AS-Tronic Rear Housing Change

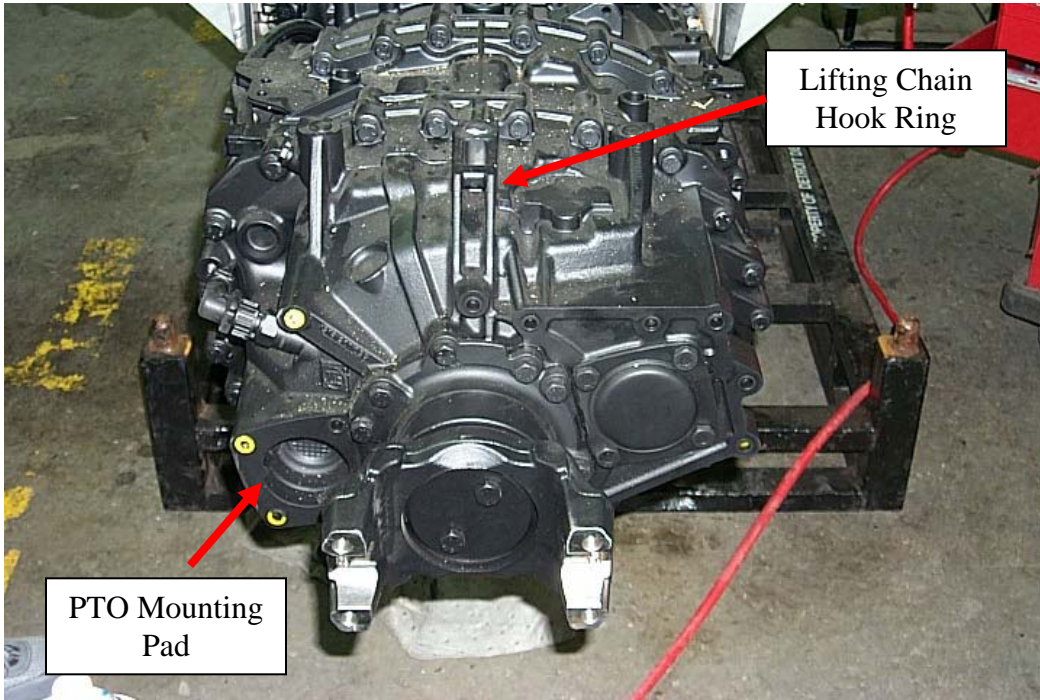
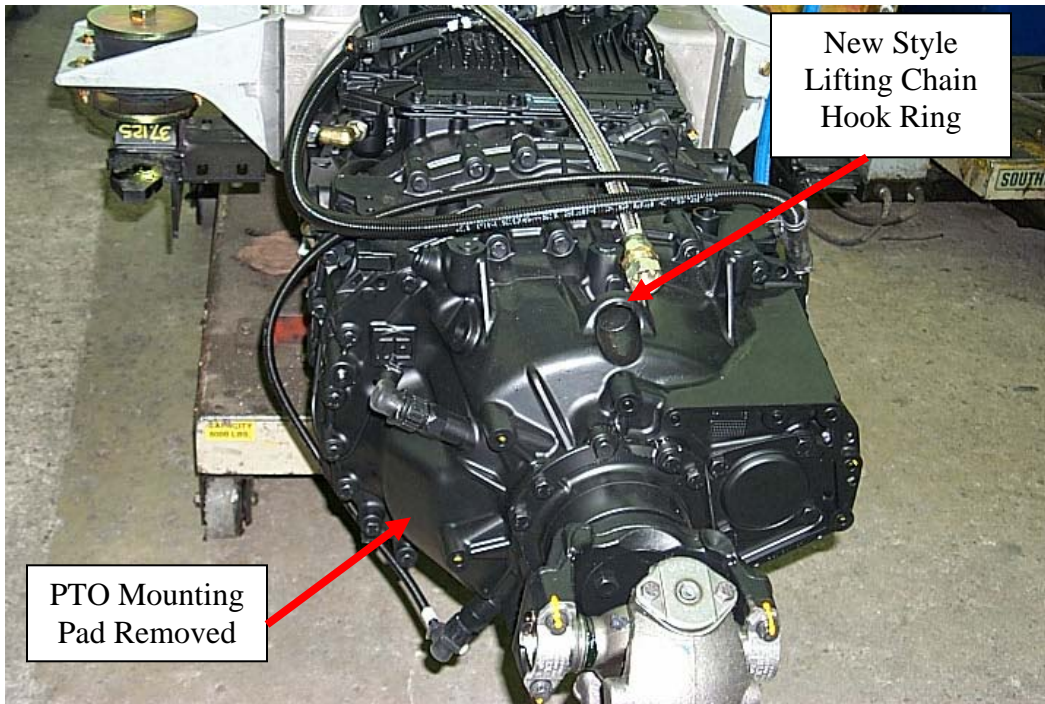
This Threaded Insert Missing
On New Housing
